Memorandum

To: Salt Lake City Planning Commission
From: Katia Pace, 801 535-6354, katia.pace@slcgov.com
Date: March 9, 2022
Re: Planned Development (PLNPCM2021-00045)
Conditional Use (PLNPCM2021-00046)

PLANNED DEVELOPMENT & CONDITIONAL USE

Request: Kevin Perry, representing the property owner, is requesting approval for a new residential development, the Bueno Avenue Apartments, at 129 S 700 East. The project proposes to consolidate 10 parcels and demolish the existing buildings on the site, a multifamily building along with associated garages/storage facilities and seven single-family homes. Subsequently the proposal is to replace what would be demolished with two buildings: a single-story amenity building fronting 700 East and a 4-story apartment building on the interior of the site. The apartment building would consist of a "Rooming House" with 65 units ranging from 1 bedroom to 4-bedroom units. Each unit would share cooking and living room facilities and would have a bathroom for each bedroom. The breakdown of the 65 units would be as follows:

C-201

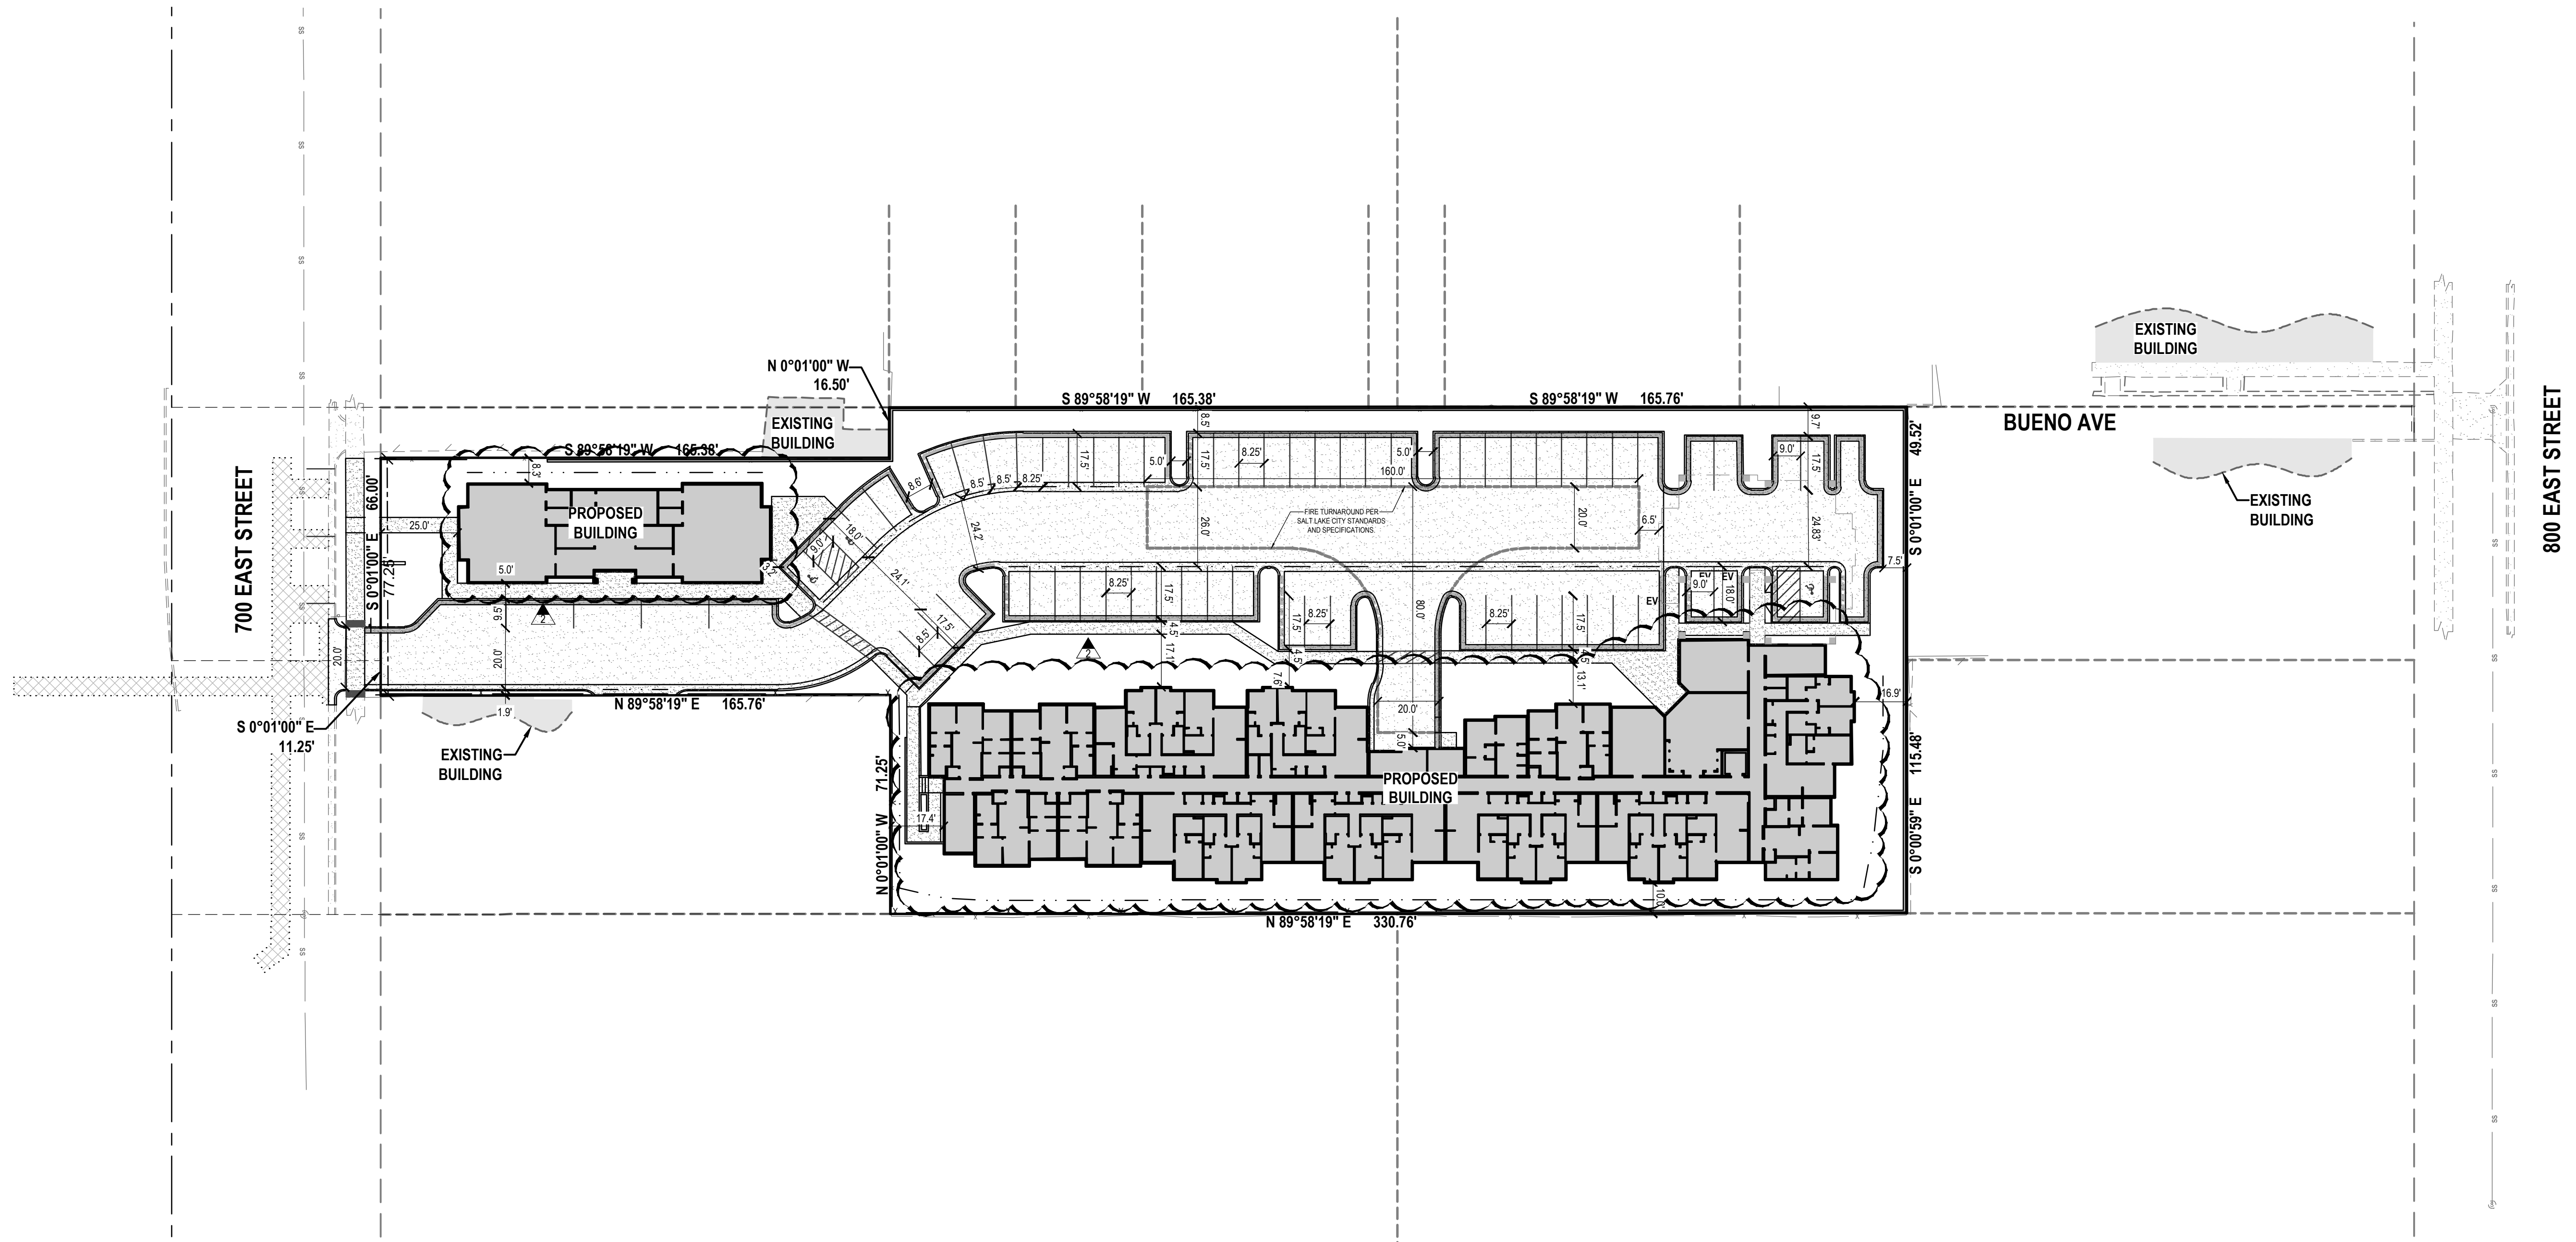
2. It looks like the Fire Department is not sure about turnaround and width for emergency vehicles, need to clarify that with Fire.
Fire Turnaround dimensions reflecting Salt Lake City standards and specifications have been provided on Dimension Plan, sheet C-201.

Fire Turnaround dimensions reflecting Salt Lake City standards and specifications have been provided on Dimension Plan, sheet C-201.

Sheet Number
A2.21

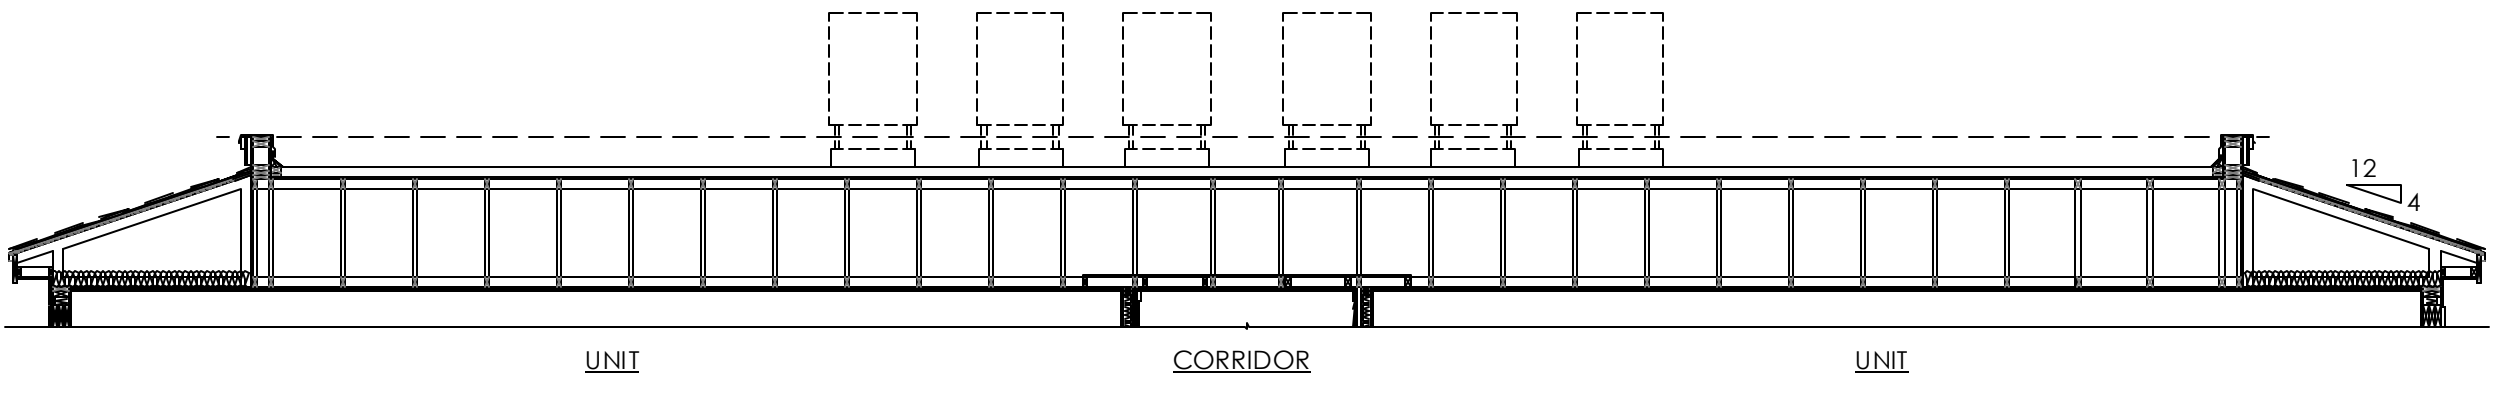
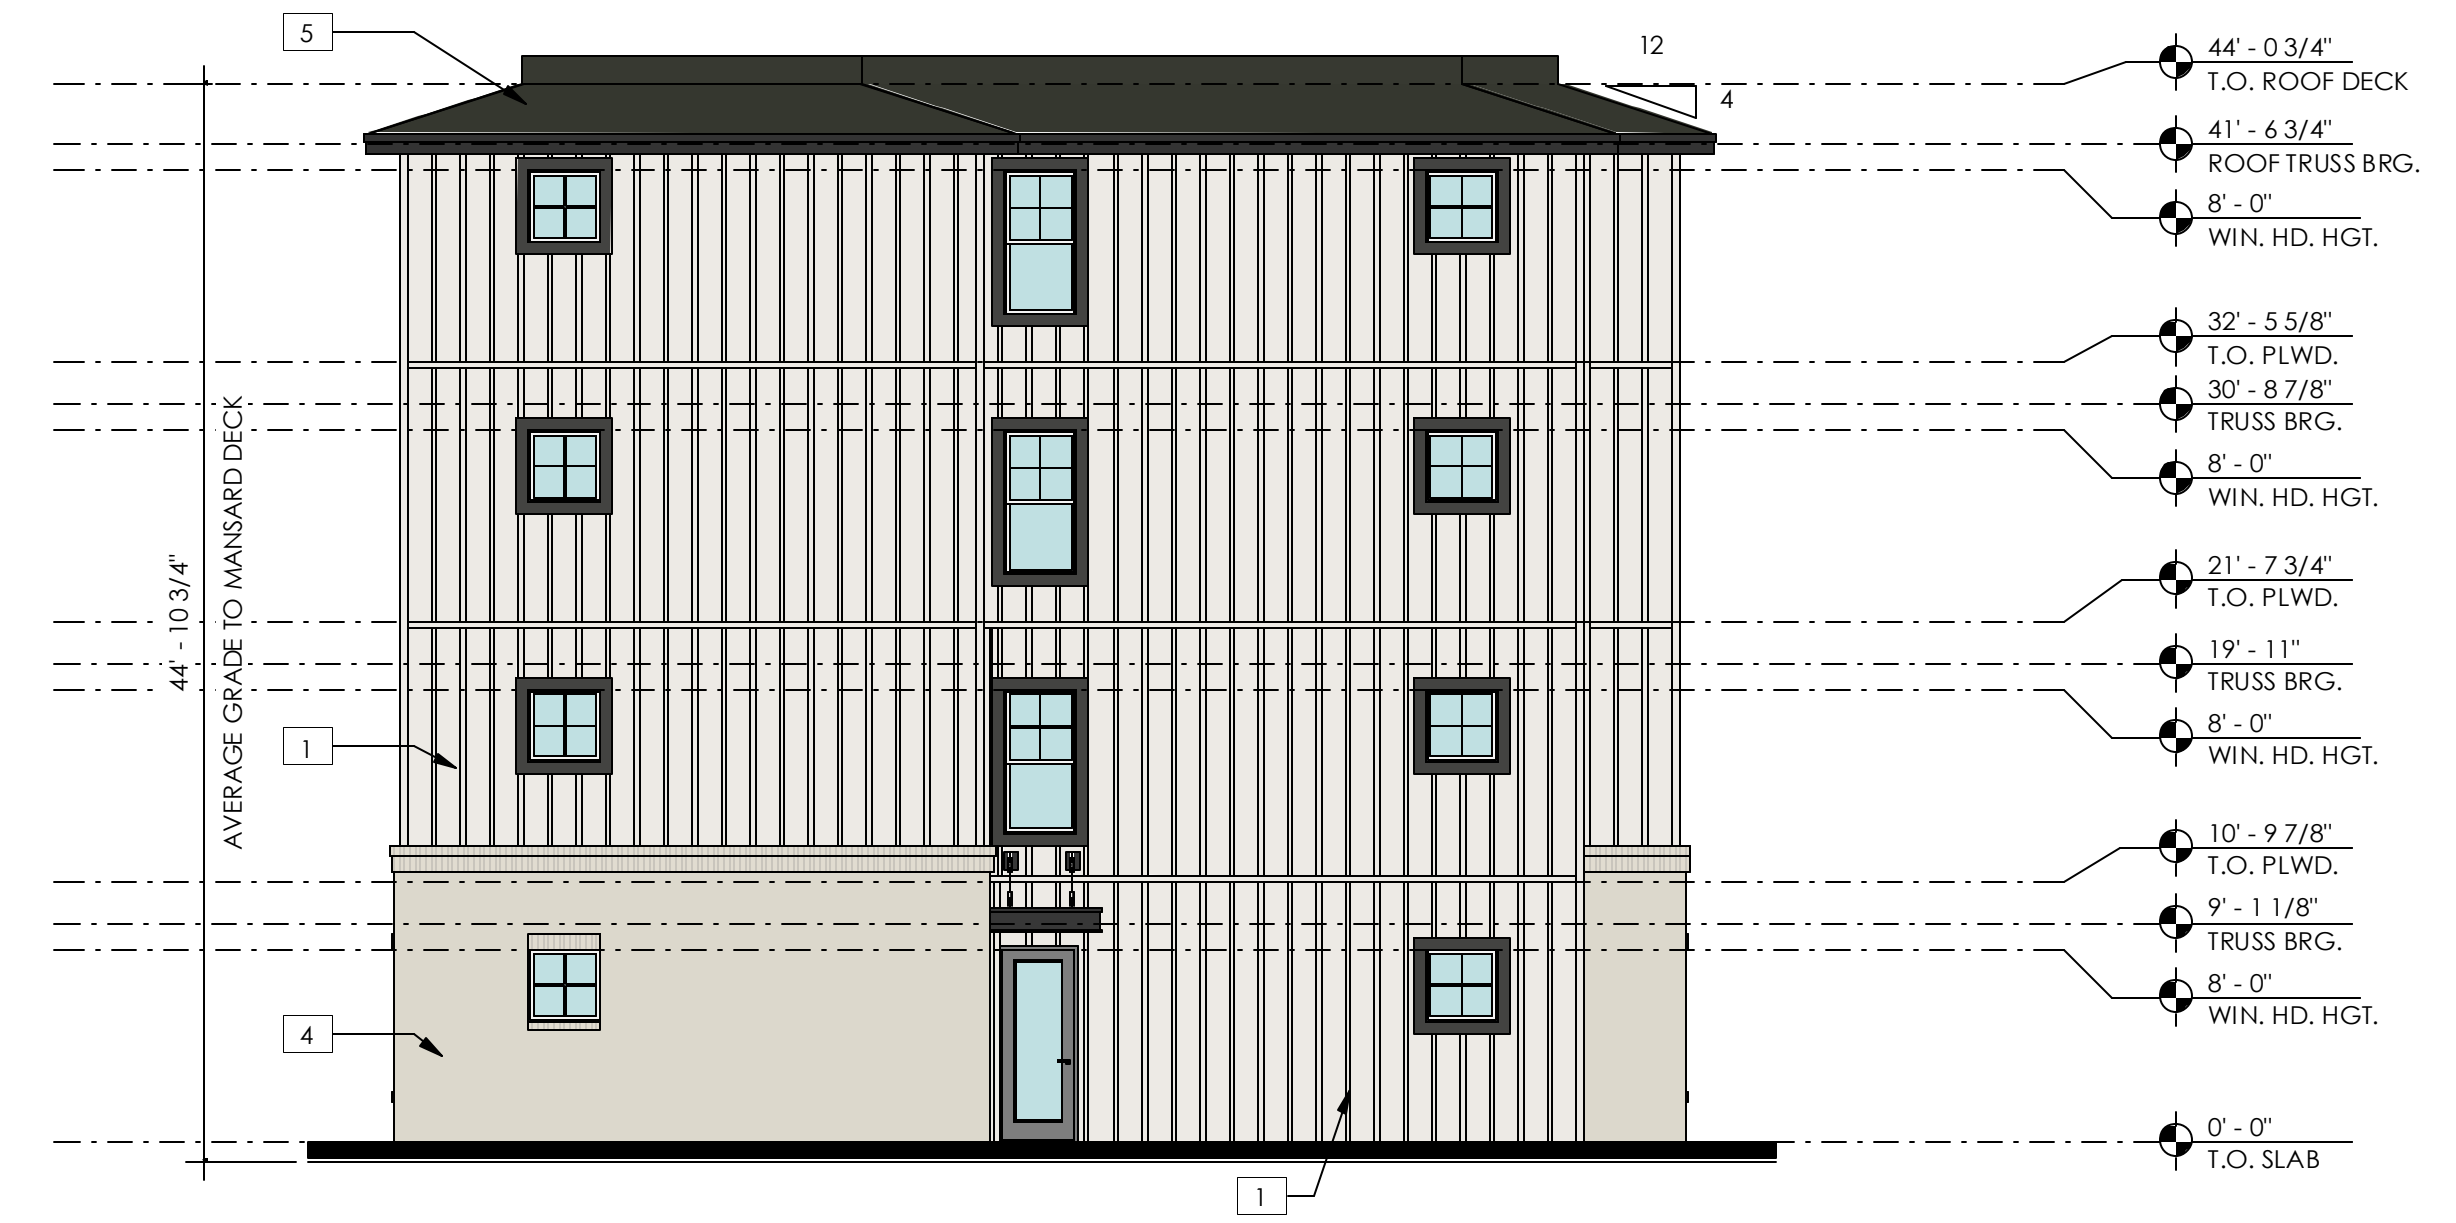
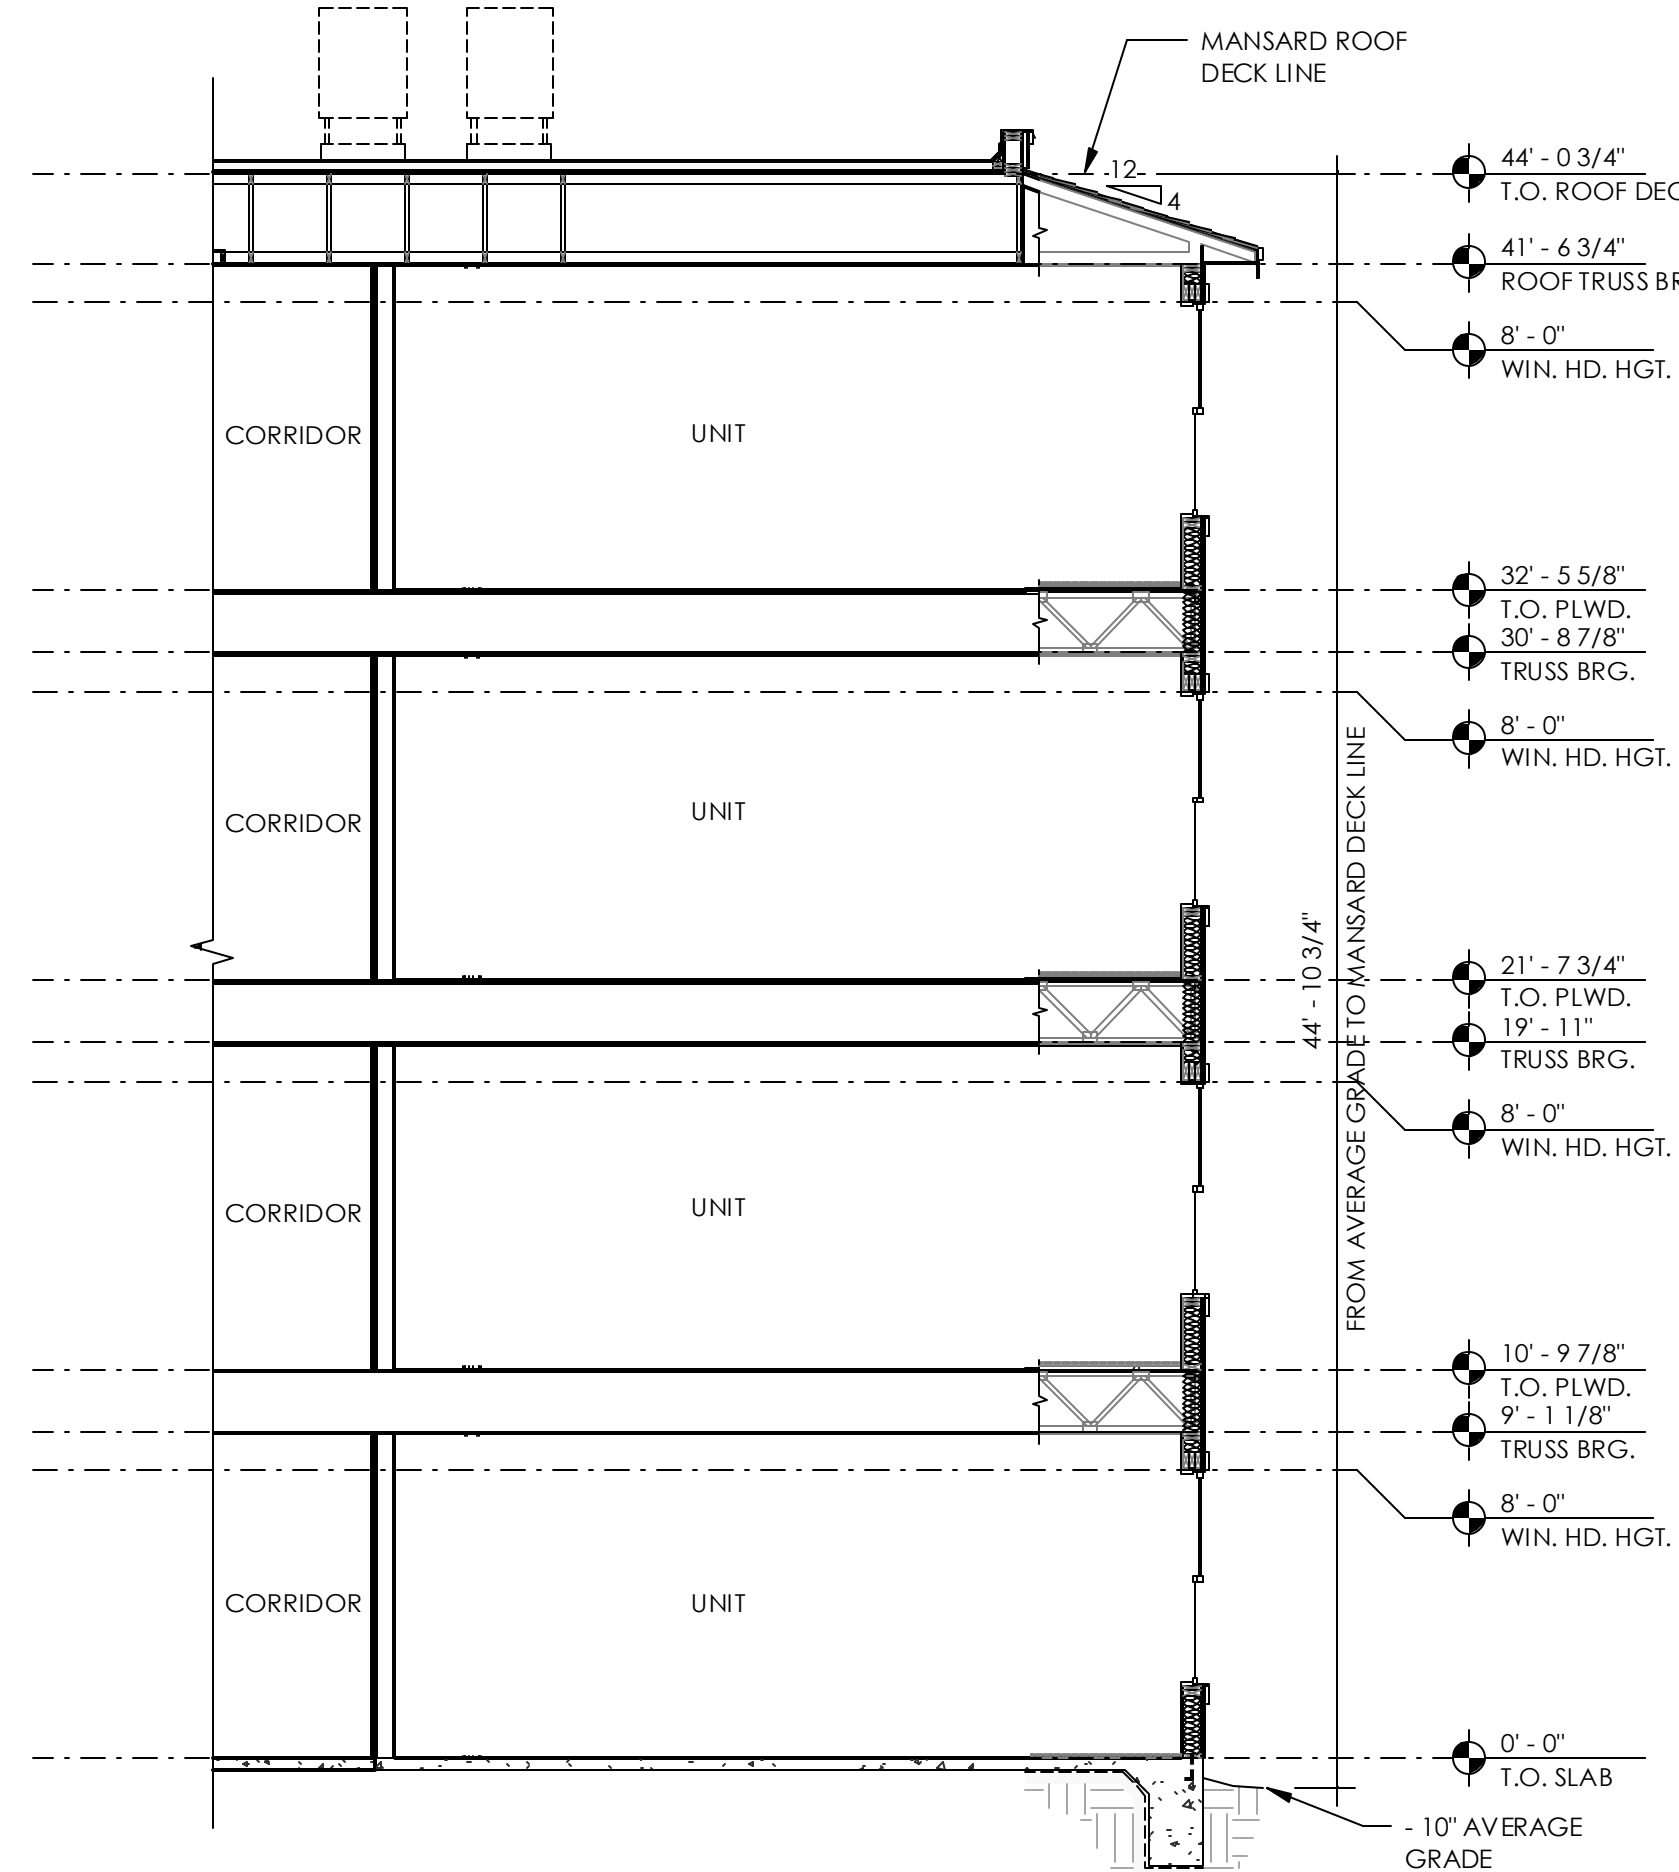
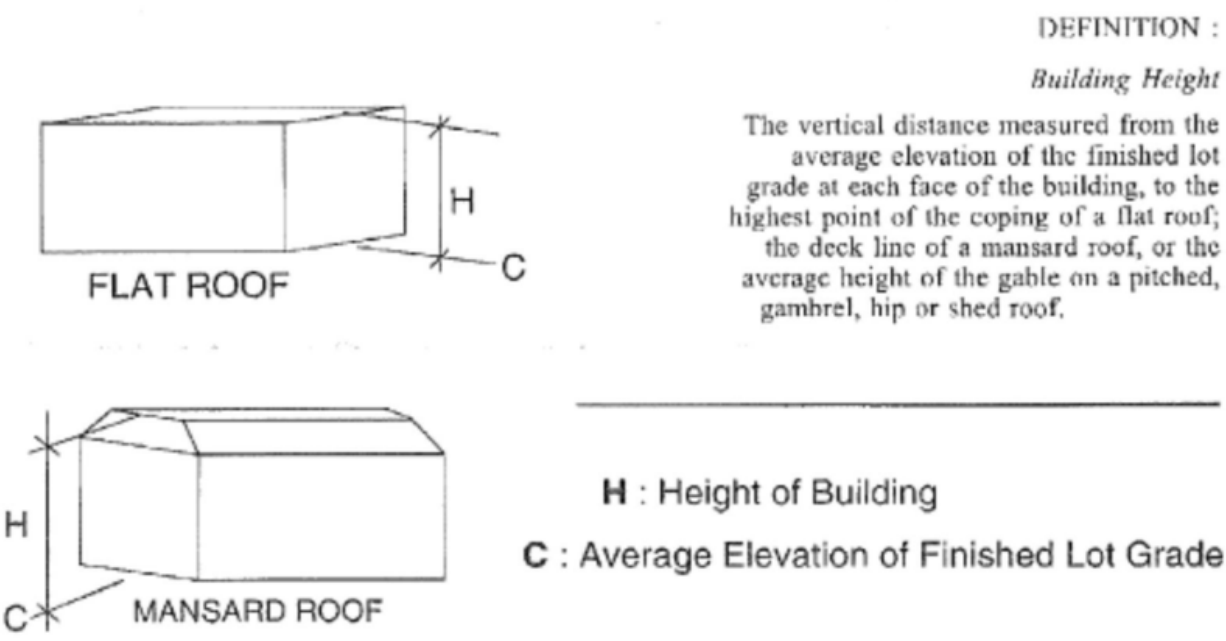
1. The drawings need to show the height of the buildings. It looks like the height is over the allowed height of 45 feet. **Please refer to sheet A2.21 for wall section depicting building height and code references for height calculation and definitions.**
